Office Action Summary	Application No. 10/593,517	Applicant(s) FREEMAN, ALAN JOHN MORRIS	
	Examiner ALEXANDER B. COMLEY	Art Unit 3746

DETAILED ACTION

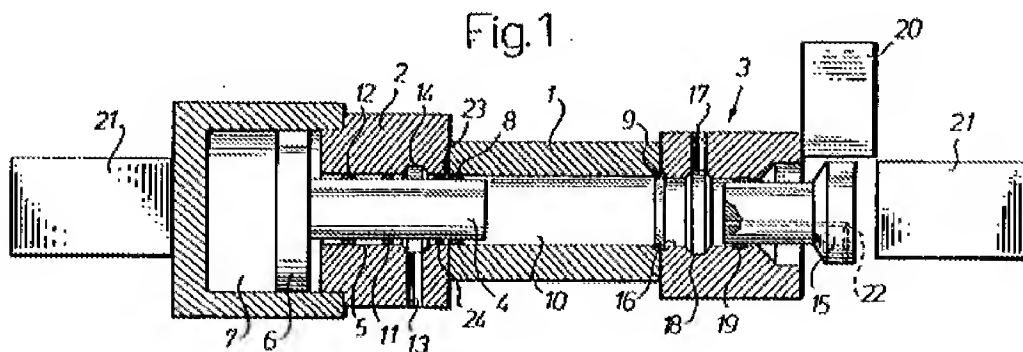
In regards to Independent **Claims 1 and 11**, and with particular reference to Figure 1 shown immediately above, Bergman discloses a pressure intensifier assembly for pressurizing foodstuffs such as tomato sauces, fruit-based pulps, and quenelles (See Col. 1, Lines 20-25). Bergman's device utilizes a cylinder-and-piston 1, 4 (i.e. barrel assembly), pressurizing means (4-7), end closure assemblies (2, 3), and a surrounding tension frame with clamping pistons 21 (See Col. 6, Lines 17-36) Just like

Applicant's tension frame and clamping pistons, the tension frame/pistons 21 of Bergman are designed to press against the end closures (2, 3) in order to take up any axial forces placed thereon during pressurization inside chamber 10 (See Col. 7, Lines 4-17) Bergman's intensifier also appears to operate in the same manner as Applicant's invention (See Col. 7, Line 52 – Col. 8, Line 34)

6. In regards to dependent **Claims 2 and 12-14**, the tension frame/pistons 21 take the form of a clamping yoke. Regarding dependent **Claims 3 & 15**, first and second seal assemblies (8, 9) are disposed on either end of the high pressure barrel 1. In regards to dependent **Claims 4 & 16-17**, the pressurizing means (4-7) is a hydraulic piston/ram assembly (See Col. 8, Lines 3-10) Regarding dependent **Claims 5 & 18**, the surrounding housing of Bergman's intensifier acts as a stand. In regards to dependent **Claims 6-7 & 19-20**, it can be seen in Figure 1 that no screws are utilized in retaining the various intensifier components together. Moreover, Bergman specifically states that his structure allows for quick disassembly thereof (See Col. 5, Lines 49-54) Hence, the barrel 1 can be opened rapidly, and therefore allows for quick detachability thereof. Regarding dependent **Claims 8 & 21**, it can be seen in Figure 1 that the right end closure 3 is retractable via its plunger member 15 when the press frame pistons 21 retract therefrom (See Col. 8, Lines 27-34) And finally, in regards to dependent **Claims 9 & 22**, it is clear that the pressurizing fluid lifts the piston 4 of the barrel assembly during pressurization.

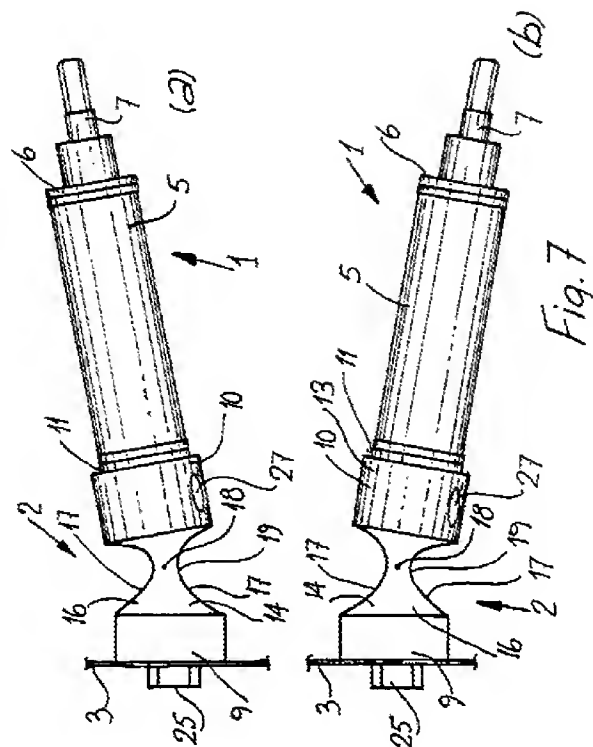
With reference to Figure 7 pictured above, Jansson discloses the use of a hinged pivot mechanism (14-19) for allowing a ram mechanism to pivot on its base (See Col. 5, line 60 - Col. 6, Line 28) Both Bergman and Jansson are aimed at providing better ram apparatuses. Therefore, to one of ordinary skill desiring a more versatile ram, it would have been obvious to utilize the pivoting techniques disclosed in Jansson in combination with Bergmann in order to obtain a predictable result; that result being a pivoting ram housing that allows for better access thereto.
